**Review of Electrical Leak Location and Electrical Resistivity
Tomography Pilot Study of the Secondary Containment System at
the Valdez Marine Terminal West Tank Farm Conducted July 2024**

22 January 2025

This review provides an assessment of the report from a pilot study undertaken by Alyeska Pipeline Service Company in July 2024, to evaluate if electrical leak location (ELL) and/or electrical resistivity tomography (ERT) are feasible methods to evaluate the integrity of catalytically blown asphalt (CBA) liner of the secondary containment system (SCS) at the Valdez Marine Terminal (VMT) tank farm. The pilot study was conducted at the West Tank Farm.

Figure 4. Photographs (a) electrical leak location survey and (b) electrical resistivity tomography (from WSP 2024a)

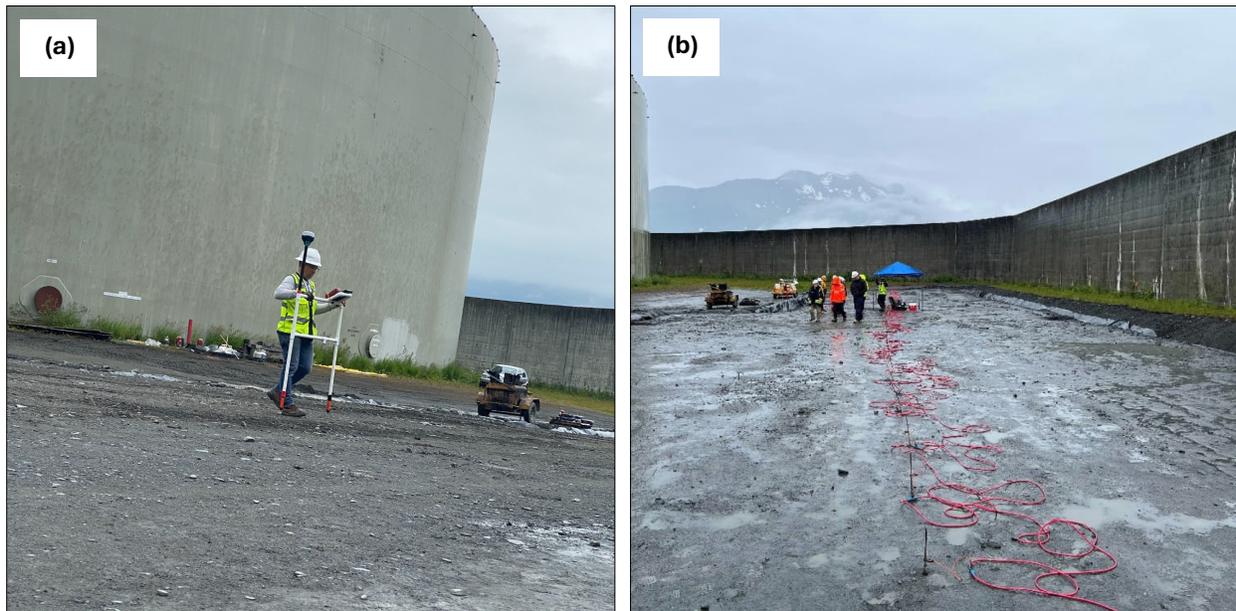
1. ***ELL can effectively locate larger leaks in the CBA.*** *East-west ELL survey transects did not detect any potential leaks but also did not detect any of the manufactured leaks. North-south ELL survey transects were effective at locating the larger manufactured leaks. Therefore, future ELL survey transects should be run both parallel and perpendicular to one another (e.g., both north-south and east-west).*

WSP notes that north-south survey transects were effective at locating the larger manufactured leaks, whereas none of the manufactured leaks were identified along the east-west survey transects. This dependence of transect orientation (north-south vs. east-west) is not common and is likely due to subsurface features that exist in the West Tank Farm, such as metal pipes, storm drains, and structural elements associated with the tank farm. These features may act as preferential flow paths for current below the liner, affecting orientation of the applied electrical field and masking electrical anomalies from defects in the CBA. Similar subsurface features are likely to exist in the East Tank Farm.

Furthermore, even though identified manufactured leaks were only detected using ELL surveys along north-south transects, the pilot study should not be interpreted to indicate that pre-existing leaks (non-manufactured) leaks do not exist along the east-west transects (or elsewhere). North-south ELL survey transects were only conducted over a limited area around the manufactured defects (less than 1/3 of the total area). Consequently, pre-existing leaks may exist but were not found detected along the north-south transects.

2. *Based on the results of the pilot study, ERT does not appear to be effective in delineating leaks in the CBA.*

ERT surveys were only conducted in a north-south orientation and not in perpendicular orientations like the ELL surveys around the manufactured leaks. However, given the data were collected in the same orientation as ELL surveys that were successful in identifying the larger manufactured leaks, the likelihood of detecting leaks with additional perpendicular ERT transects is small. Therefore, we agree that ERT does not appear to be effective for delineating leaks in the CBA at the VMT.

We agree that based on the findings of this study, ELL has been demonstrated to provide a method for indirect assessment of leaks in the SCS for the VMT East Tank Farm.
